SITE PLAN
SCALE: 1/8" = 1'-0"

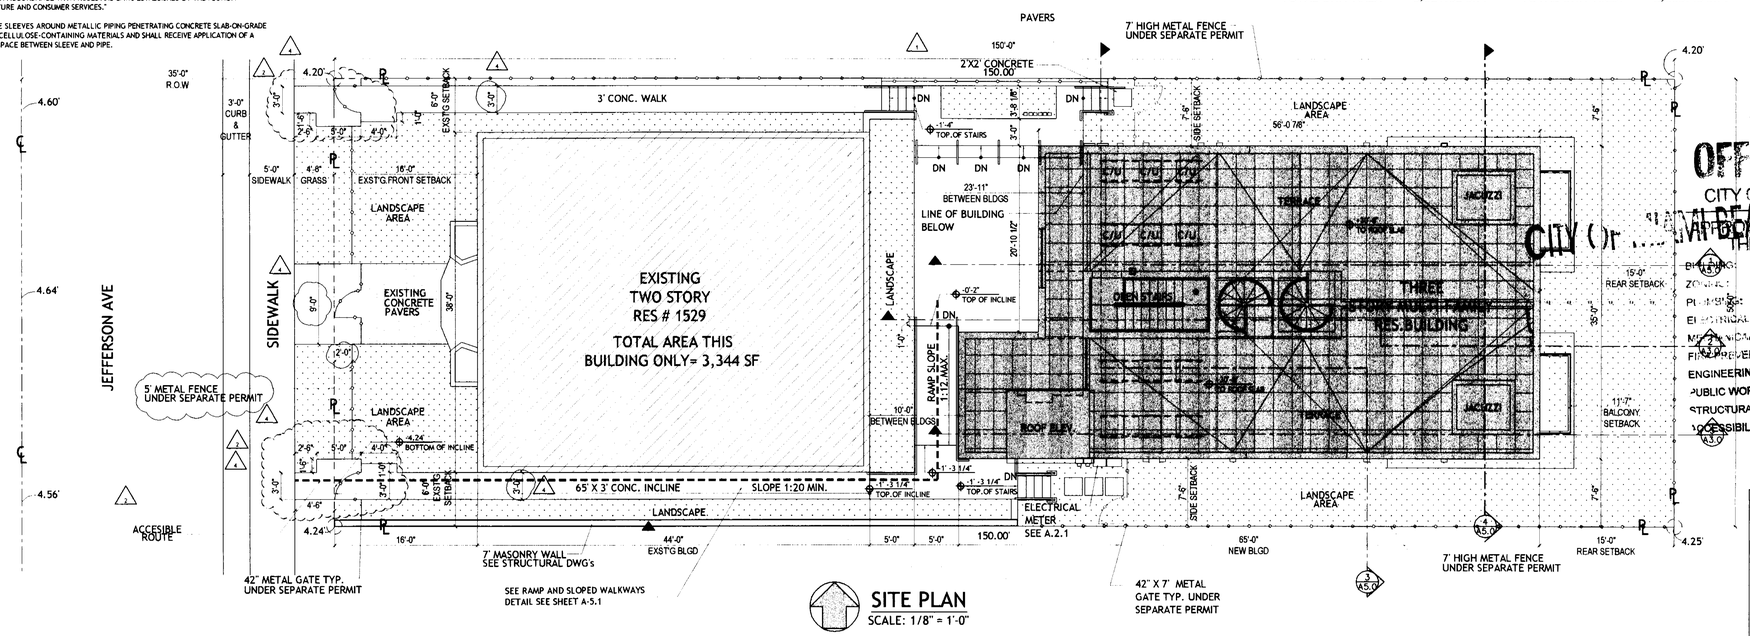
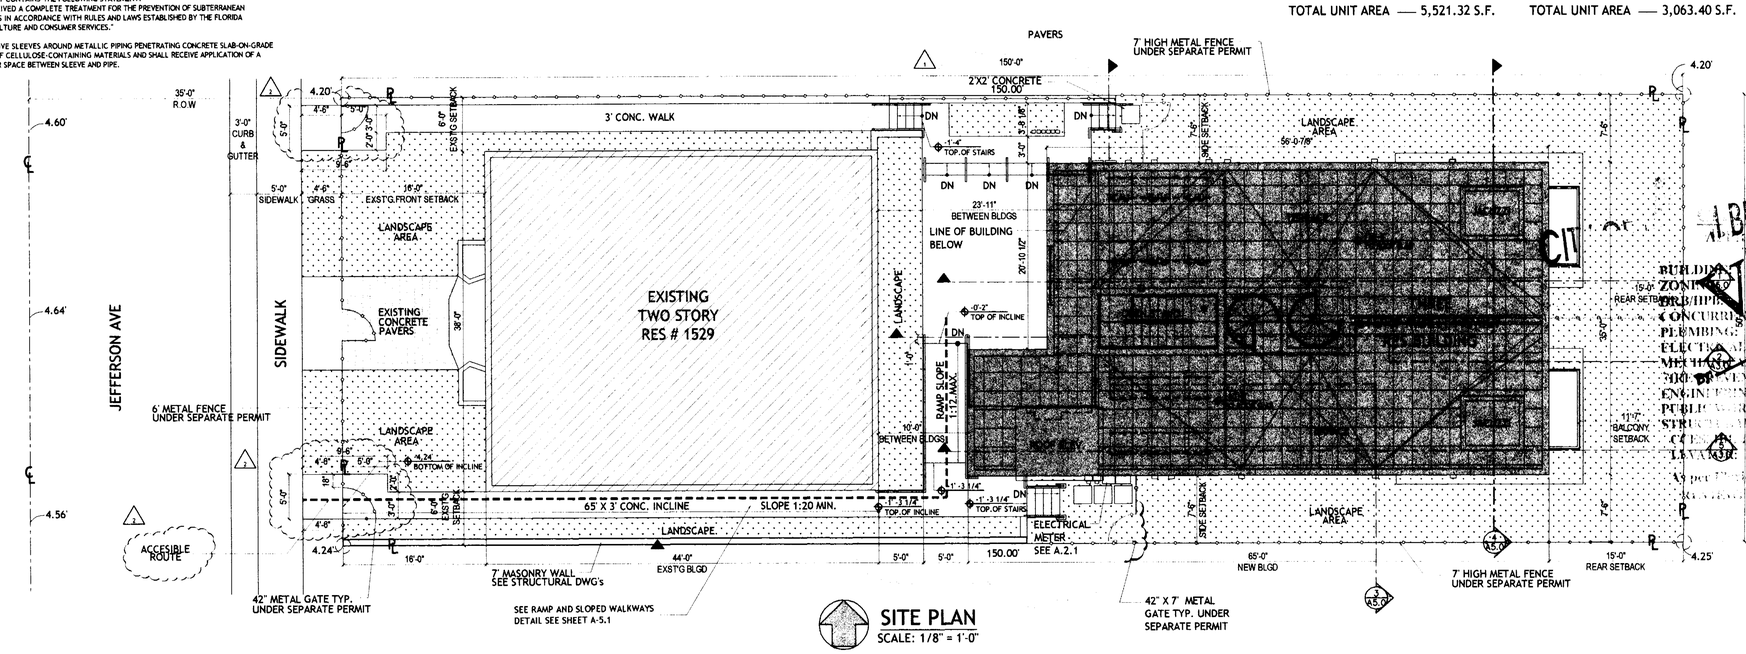
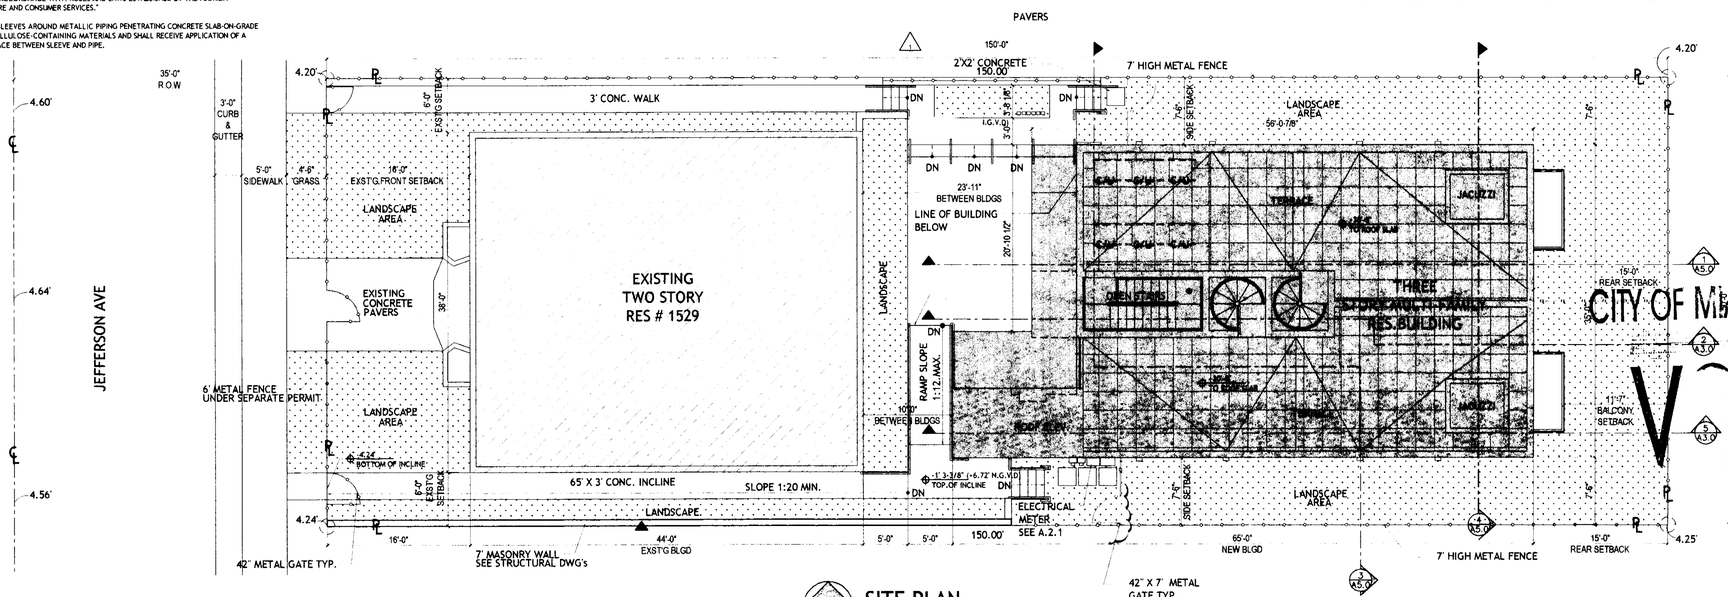
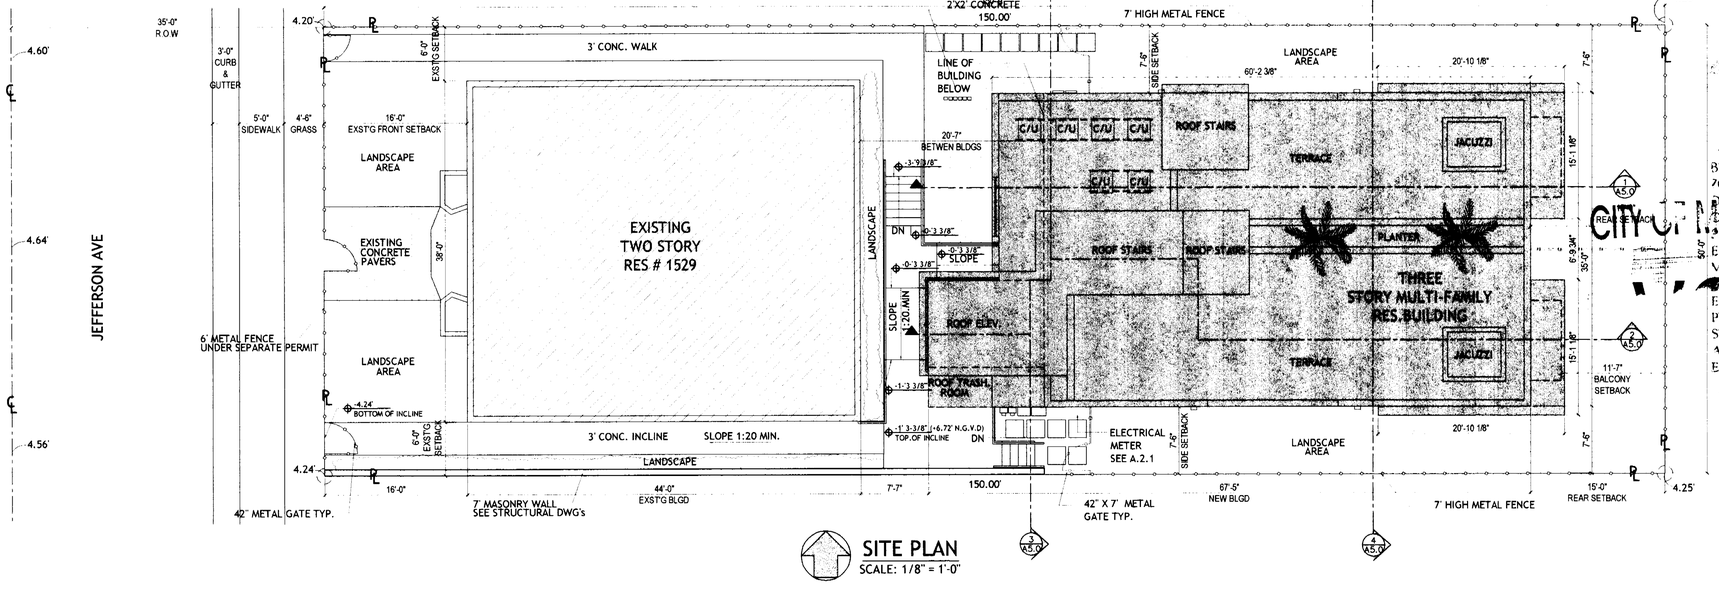
-Show water and sewer on site plan.
Please see sheet A1.0, water and sewer lines are now shown.

A-2.4

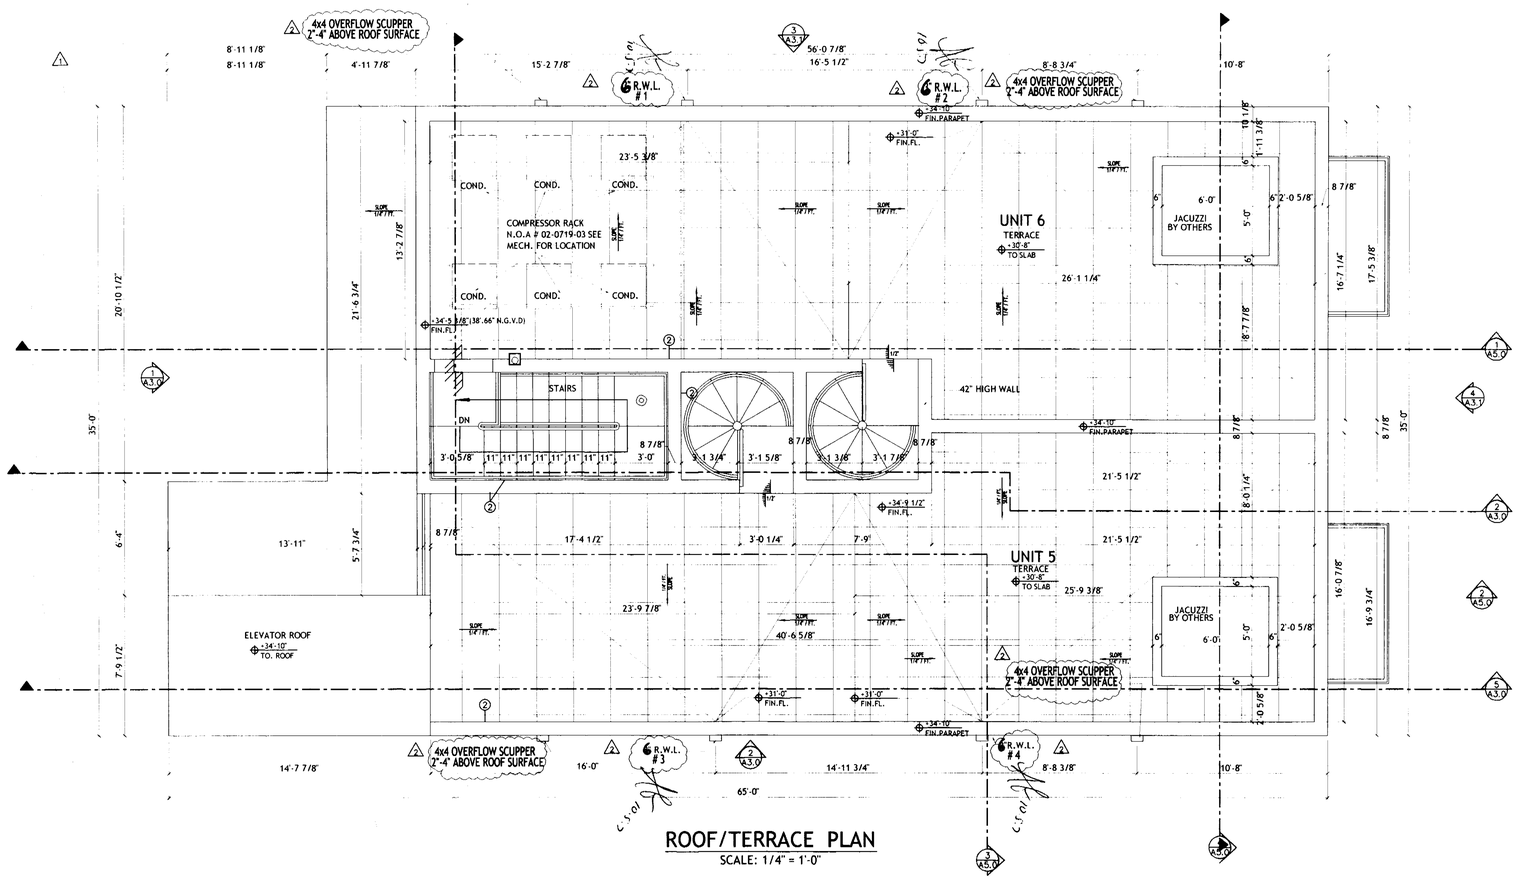
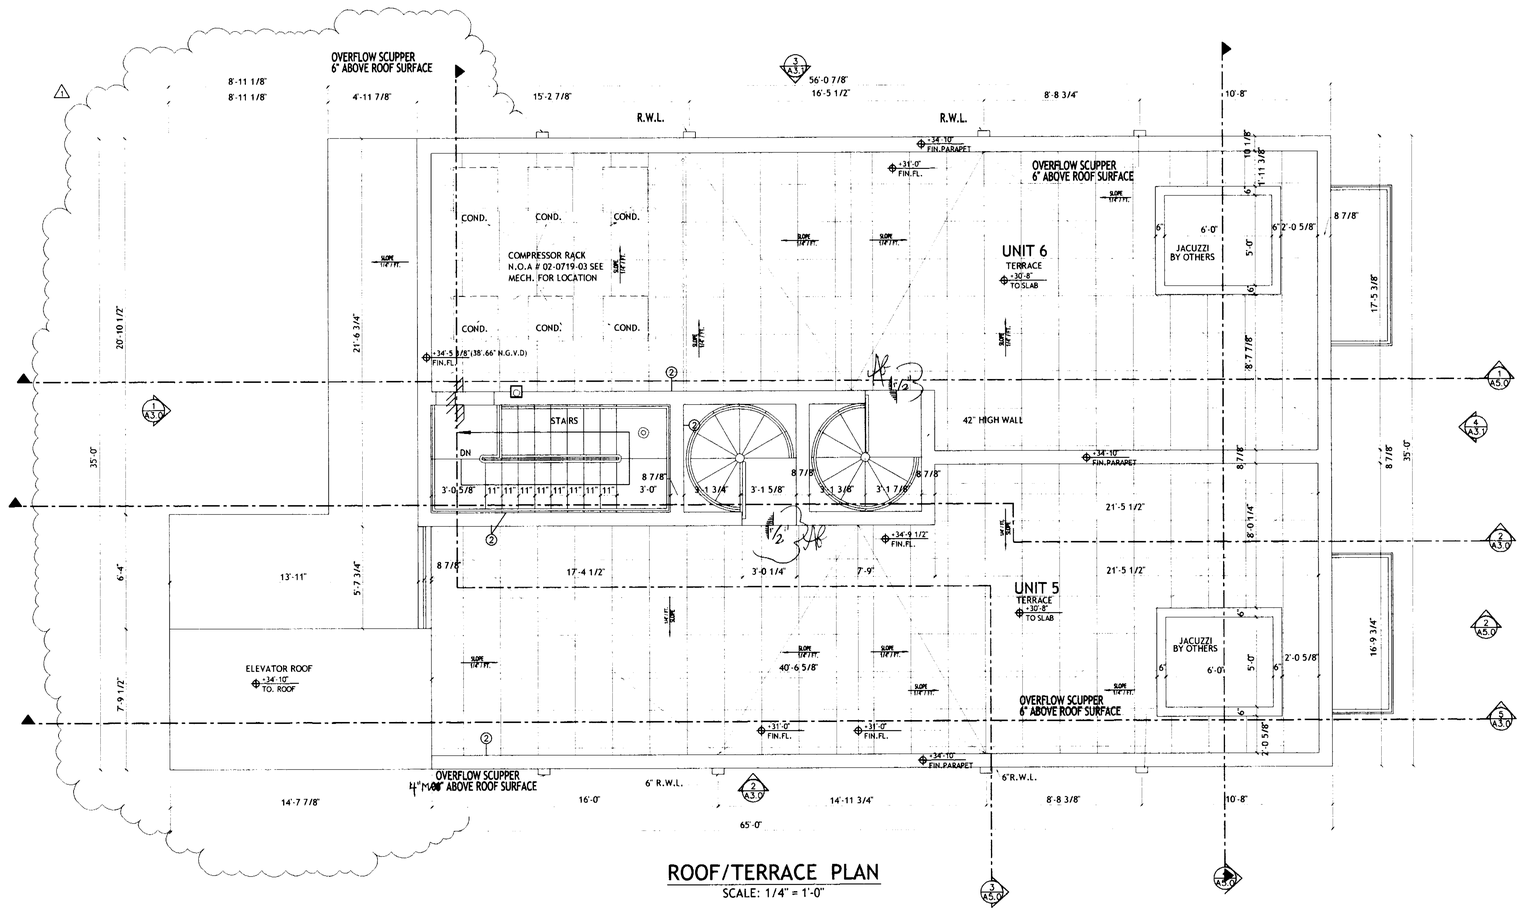
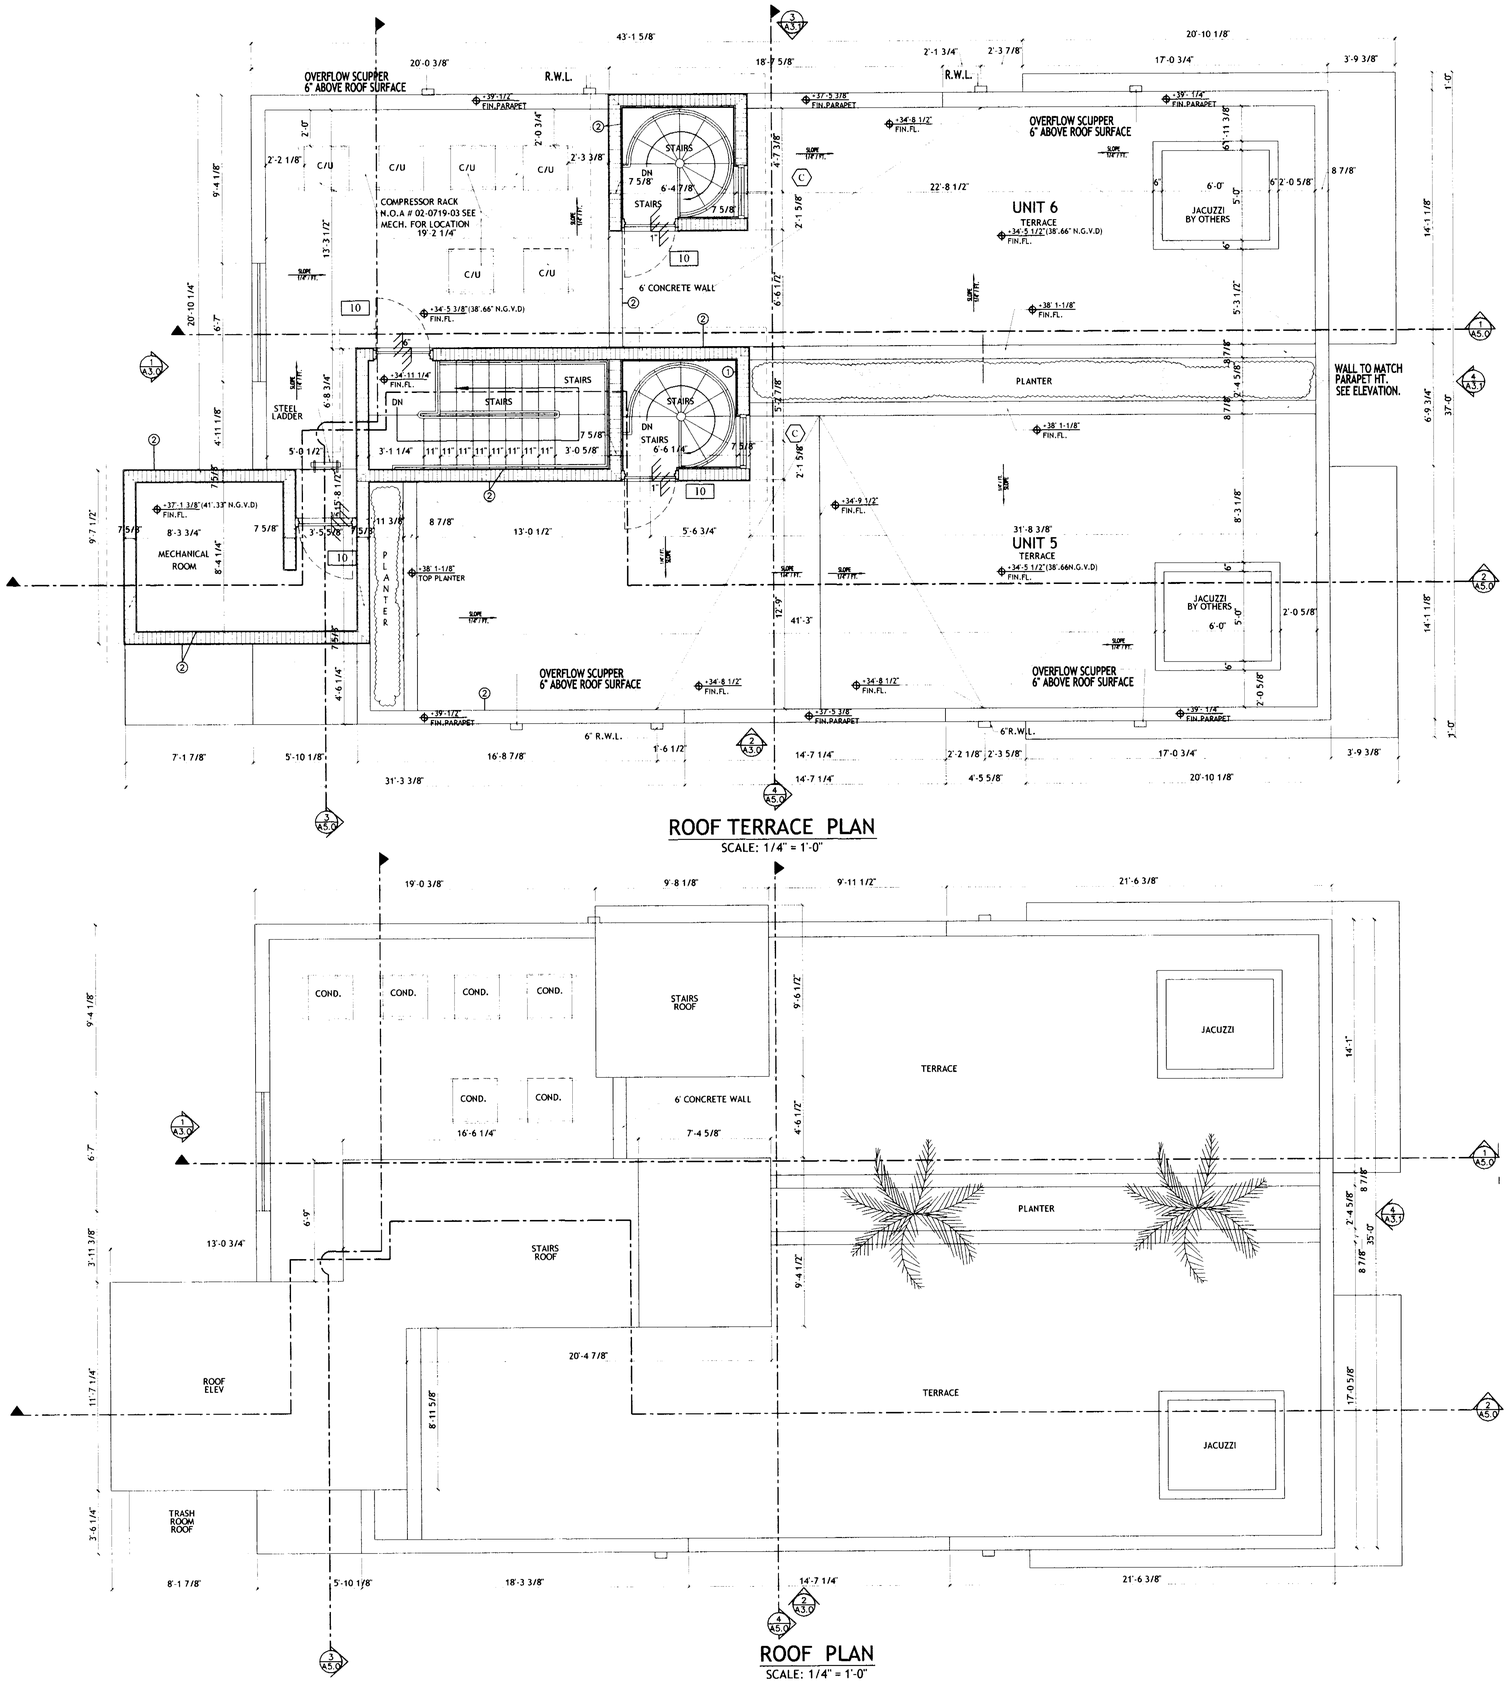
Assign Date 5/25/2007 Due Date 5/25/2007 Status Date 5/25/2007
Status Time 12:00:00AM Status CO: CO=Correction Notice Record By BUILZEIJ
Assign To JZ
Comment
Not corrected.
Advised to drop off.

Need to add roof dimensions for drain sizing.
Please see sheet A2.4, vertical leader size chart, drained roof area and roof dimensions.

Drain size is determined by the area to be drained and sized to the tables in the plumbing section.
Please see sheet A2.4, vertical leader size chart and drained roof area.

The overflow scuppers shall also be determined by the sizing table in the FBC, Building.
Please see sheet A2.4, vertical leader size chart, min. leader and overflow scupper diameter.
